Re: Corrective Action Plan Review
Plantation Pipe Line Lewis Drive Release, 112 Lewis Dr., Belton SC
Site #18693
Petroleum Pipeline Release December 8, 2014
Corrective Action Plan (9/1/16), received September 2, 2016
Agency Meeting with Plantation Pipe Line and ch2m November 4, 2016
Site Visit December 6, 2016 with Scott Powell and Patrick Ferringer with ch2m
Telephone Conversation with Scott Powell January 4, 2017
Anderson County

**Re: Proposed Corrective Action Plan for the Plantation Pipeline Lewis Drive
Release - Site # 18693**

ATTACHMENT 1

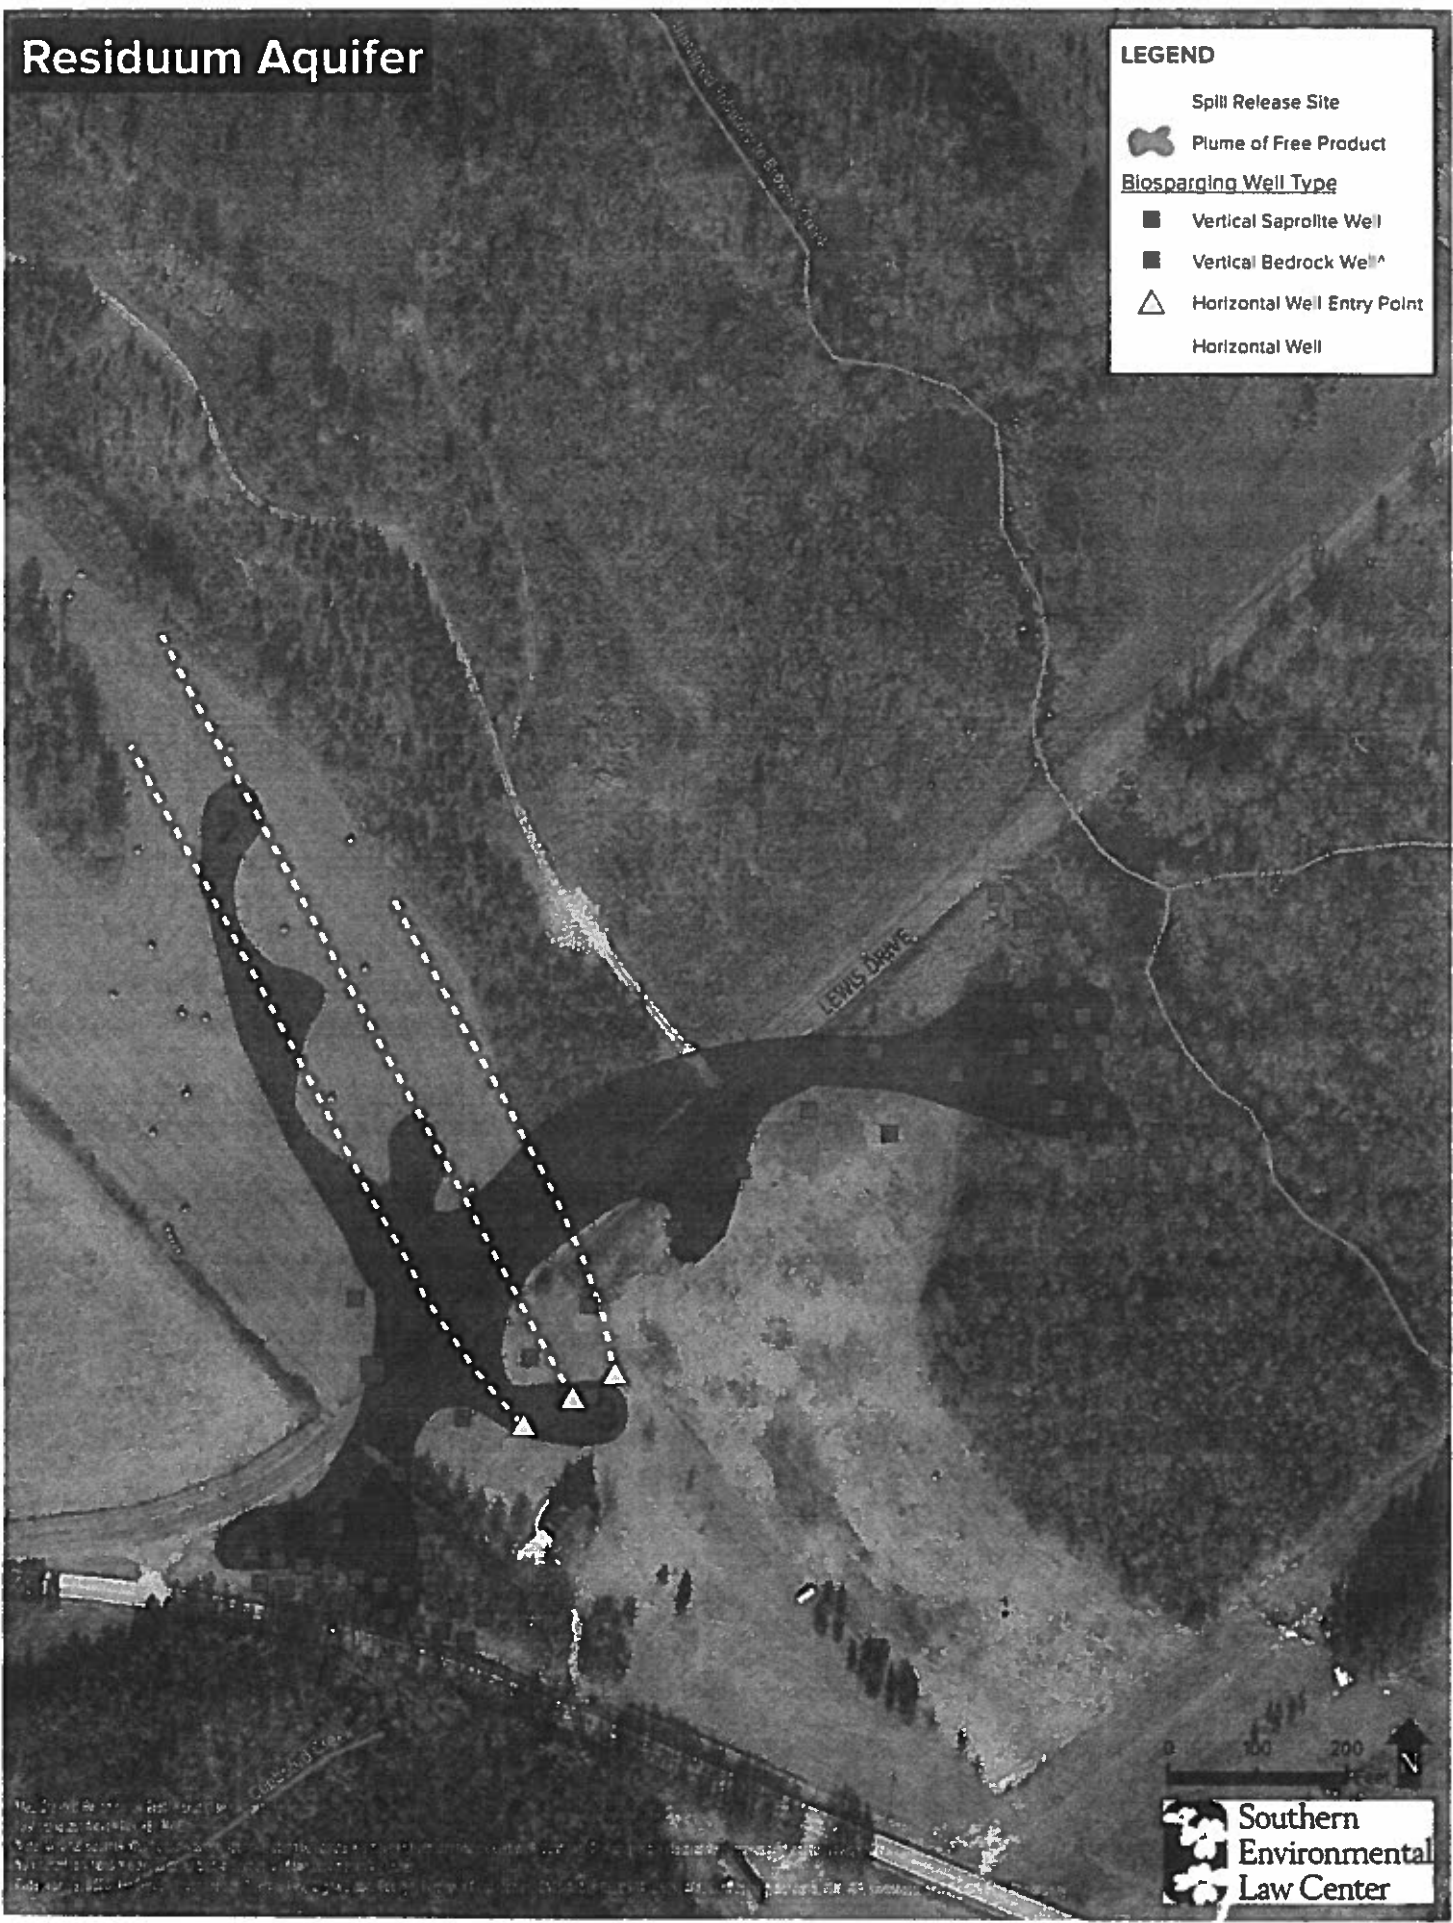
The companies’ consultants have defined a plume of free product in the overlying residuum and in the bedrock aquifer,¹⁹ but have not proposed biosparging in several portions of the plume. Figure 7 of the CAP shows product extending in the overlying residuum in four directions: 1) about 1,000 feet to the east-northeast from the spill site along and south of Lewis Drive toward the Browns Creek tributary, 2) about 1,000 feet to the north-northwest into the hayfield zone, 3) about 300 feet to the east, adjacent to a former residence, and 4) about 300 feet to the south-southwest toward Calhoun Road and Cupboard Creek. These areas are identified in the map included as Attachment 1.

Additional biosparging should occur in each of these areas. Only the second area in the hayfield zone is currently addressed in the CAP. The horizontal well biosparging solution

proposed in that area may be effective in breaking-down constituents to the north, but a final array of intercept biosparging wells should also be deployed at the northern end of this plume, between the current monitoring wells MW-30 and MW33T. This array is necessary to prevent contaminants from continuing to release to the north and northeast. The plumes extending east-northeast toward the Browns Creek tributary and south-southwest toward Cupboard Creek (areas 1 and 4) are not addressed until the biosparging arrays at the distal ends of the plume in the surface water protection zone. Additional wells should be installed in the center of these portions of the plume, especially along Lewis Drive. In addition, given the trajectory of these portions of the plume, the arrays in the surface water protection zone should be extended so that they are also on the north side of Lewis Drive along the Browns Creek tributary, and on the other side of Lewis Drive from Cupboard Creek toward MW-36. The portion of the plume extending east toward the former residence (area 3) is not addressed at all. Vertical or horizontal biosparging wells should be installed in that area.
